Mobile Pentium® II Processor Specification Update

Release Date: October 1998

Order Number: 243887-003

Figure 1. V_{CC}/V_{CCP} Timing Requirements (Mobile)

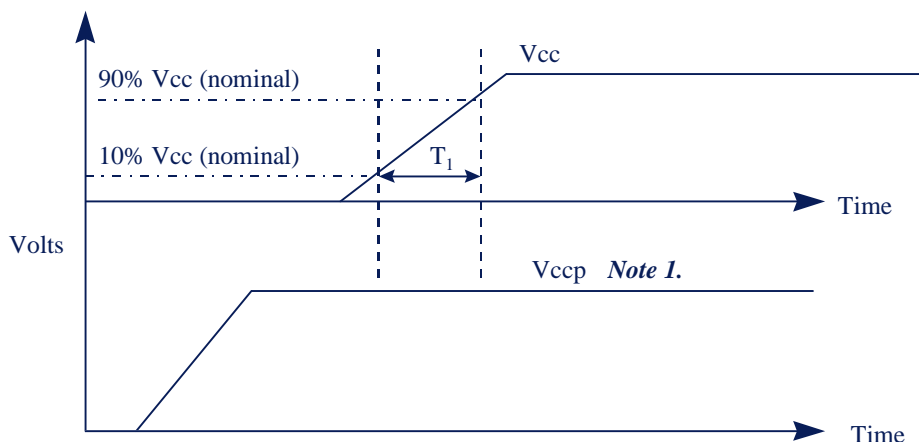
PROBLEM: The processor uses the PWRGOOD signal to ensure that no voltage sequencing issues arise; no pin assertions should cause the processor to change its behavior until this signal is asserted, when all power supplies and clocks to the processor are valid and stable. However, if V_{CC} ramps up before V_{CCP} , it will cause the processor to enter an invalid state.

WORKAROUND: For Mobile Pentium II processors, ensure that V_{CC} ramps after or with the L2 cache IO voltage (V_{CCP}). If V_{CCP} ramps after the V_{CC} , a delay circuit can be placed on the core V_{CC} to ensure that V_{CC} ramps at the same time or after V_{CCP} as shown below in Figure 1.

Figure 2. Workaround Flowchart: SMBALERT#-Driven System

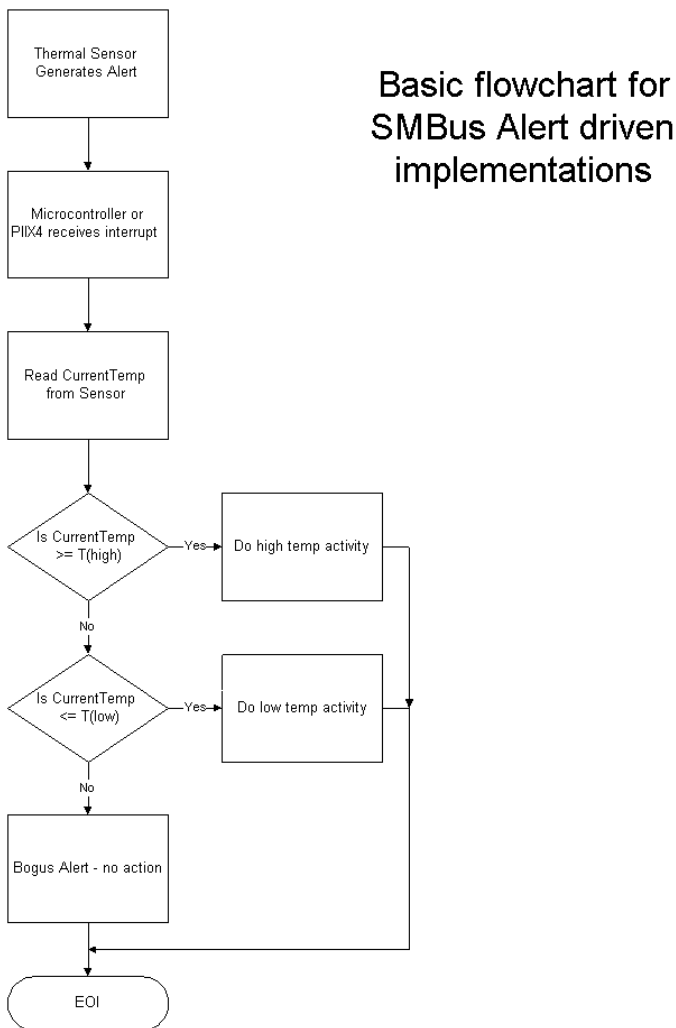
Under the conditions described below, the thermal sensor incorrectly generates the SMBALERT# interrupt. *All* of the following conditions must be met to trigger a false interrupt:

WORKAROUND: Three different (mutually exclusive) workarounds are possible:

1. Before servicing an interrupt from the thermal sensor, read and compare the processor thermal reading with the threshold limits (T_{HIGH} or T_{LOW}). Figures 2 and 3 provide basic flowcharts for the implementation of this workaround in an interrupt driven system.
2. If the firmware implemented polls the Status Register only, then before taking any action, re-read the temperature register and do a comparison with the alarm threshold limits (T_{HIGH} or T_{LOW}) to determine if the value is actually still within the temperature window.
3. Use a temperature polling scheme to monitor the processor temperature.

Figure 5.6. Cross Sectional View With Vertical Dimensions

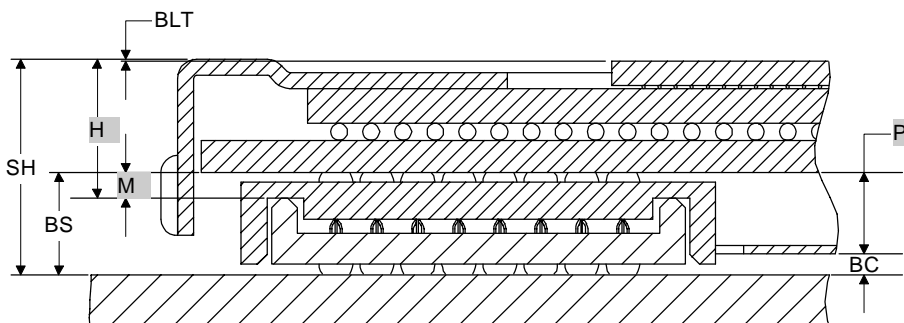
B12. Misabeled Vertical Dimension Parameters

Figure 5.6 in the *Mobile Pentium® II Processor at 233 MHz, 266 MHz, and 300 MHz* datasheet should be replaced by the following figure:

Symbol	Parameter	Min	Nom	Max	Units	Figure
H	Processor Height	4.40	4.55	4.70	mm	5.6
M	Plug Height	0.91	1.03	1.15	mm	5.6
P	Bottom Cover Height	--	2.54	2.81	mm	5.6
BLT	Bond-Line Thickness	0.01	0.12	0.23	mm	5.6
